Amendment No. 4

Sub: Amendment to the Bidding Document

Ref.: Notice Inviting Bid ref. HITES/PCD/NCI-AIIMS/03/17-18 dated: 22.09.2017 read with its Amendment No. 1, Amendment No. 2 and Amendment No. 3 dated 25.10.2017, 26.10.2017 and 14.11.2017 respectively.

PROJECT
NCI - AIIMS
AT JHAJJAR
HARYANA

BASEMENT PLAN-1

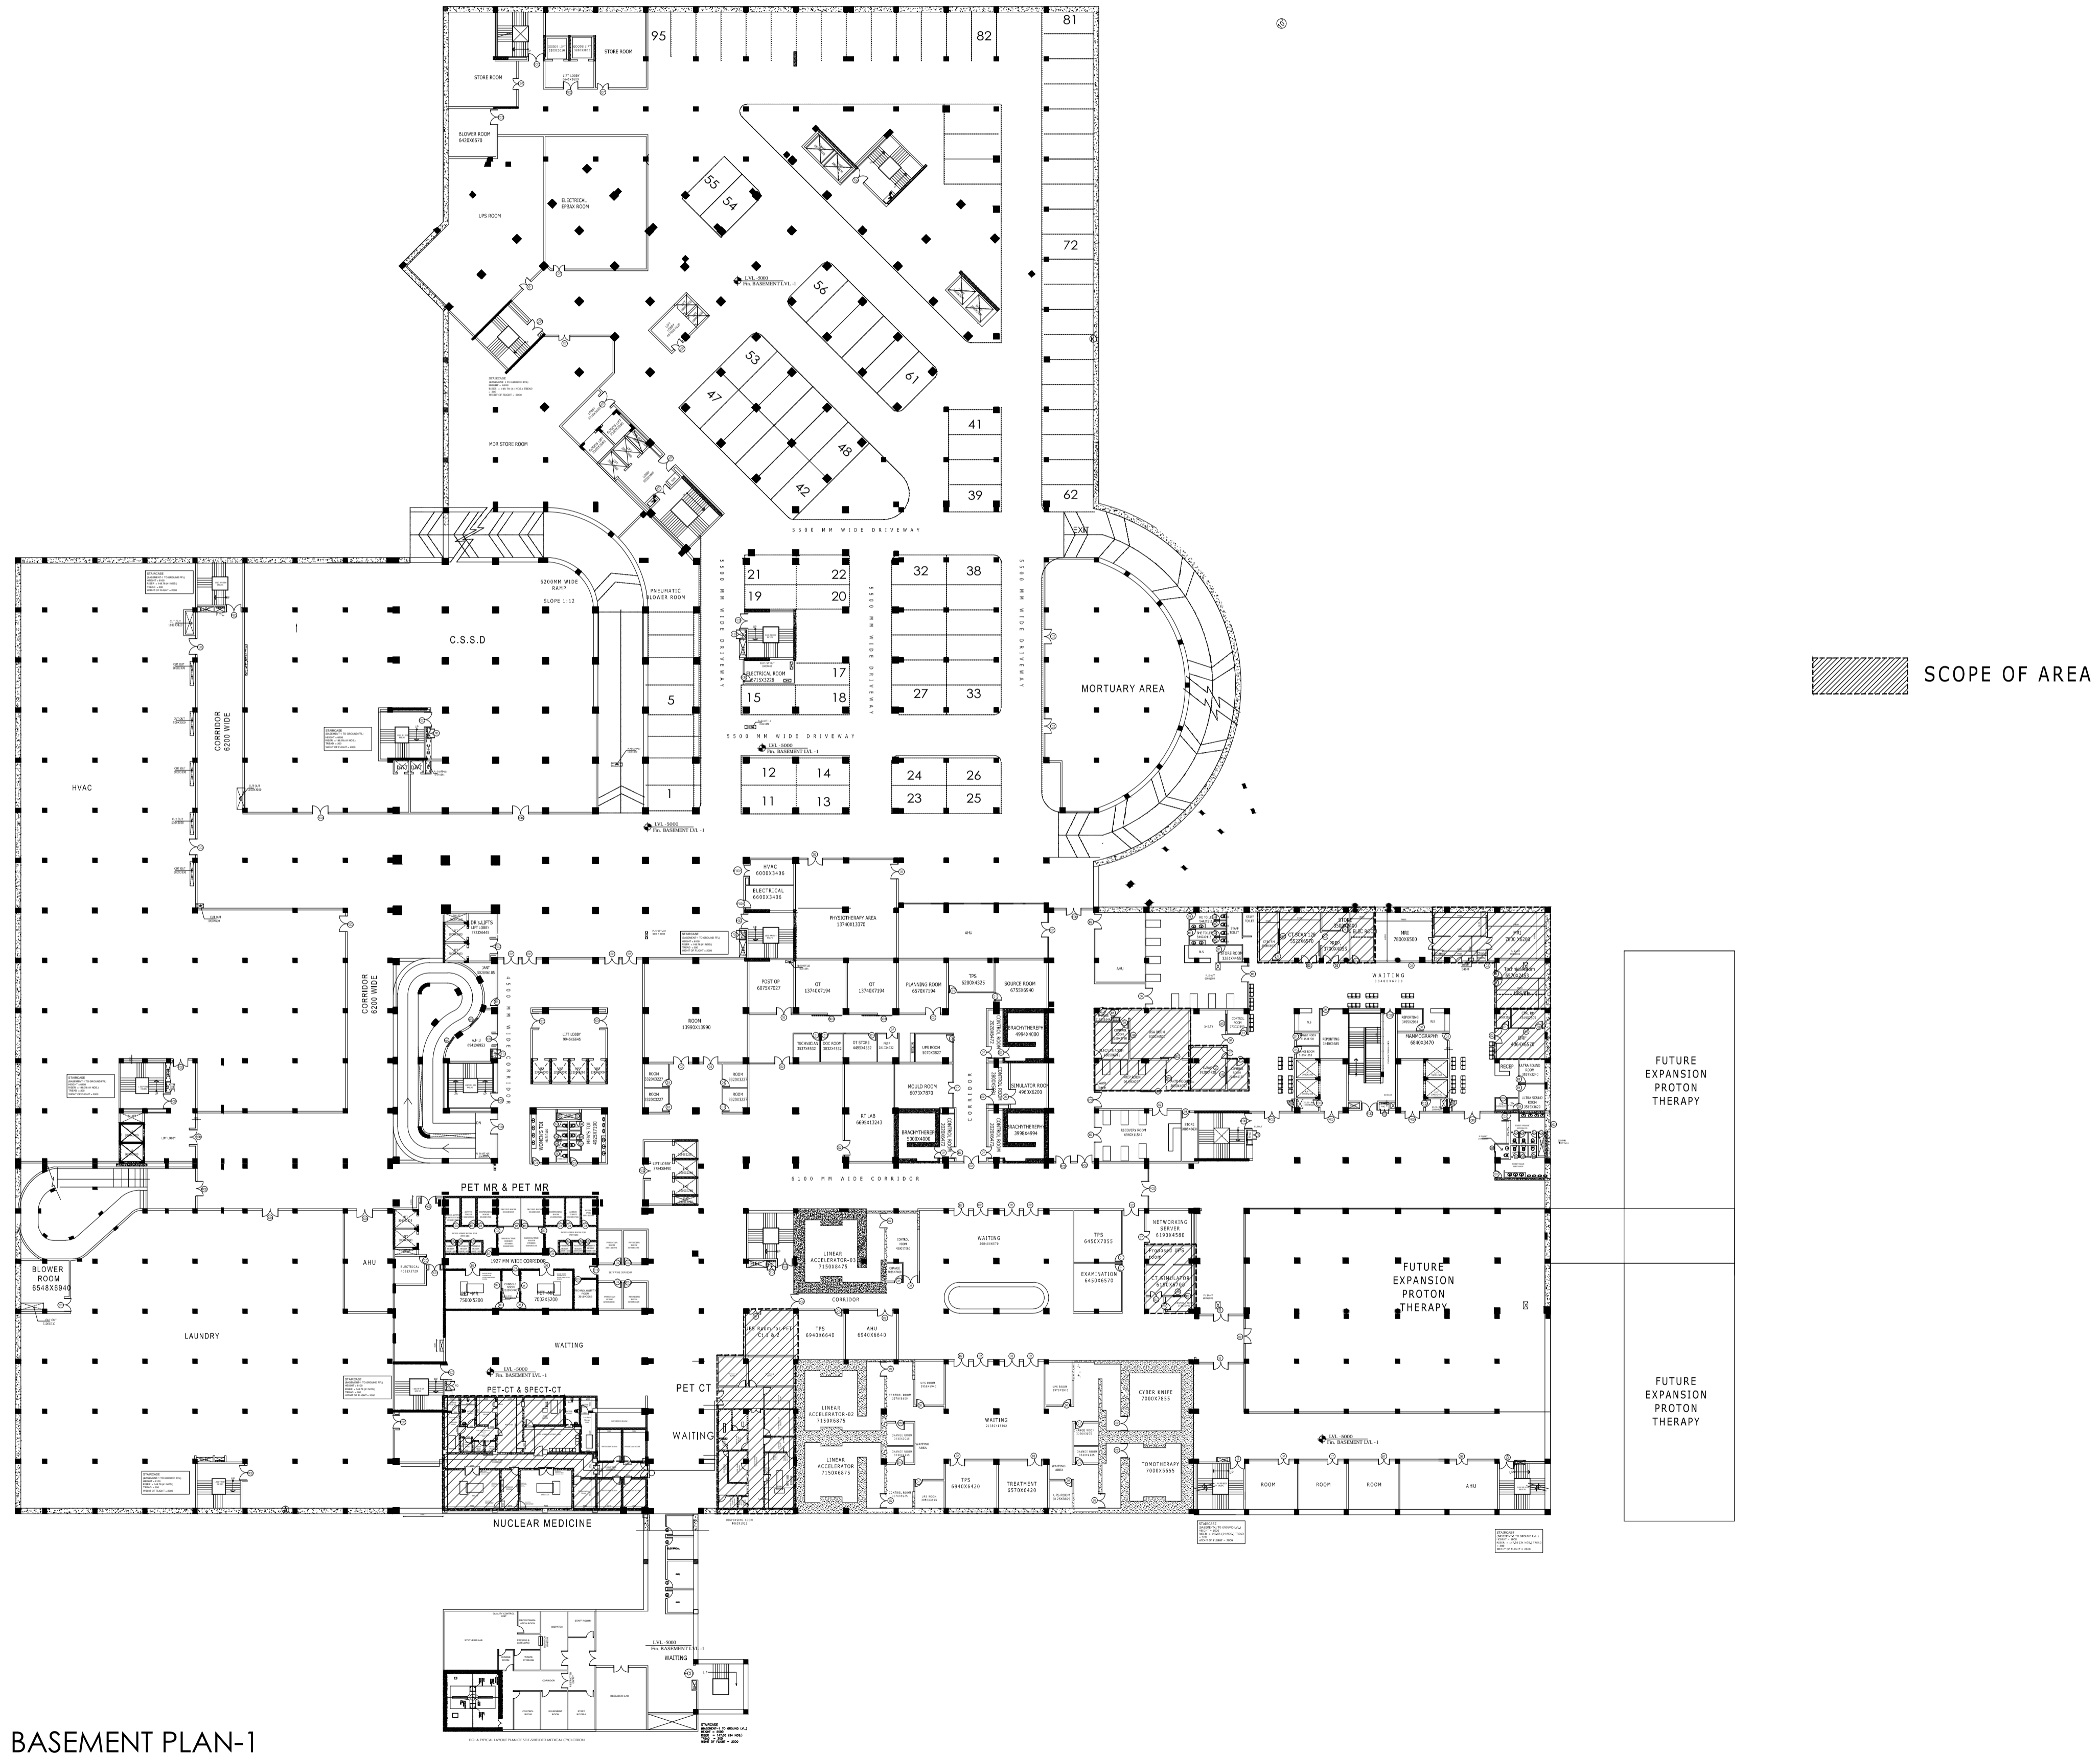
1. SITE MODIFICATION AREA for all items under this NIB-

Revised site plan showing the location of the nuclear medicine equipment, as well as site modification area is attached in the following page for reference.
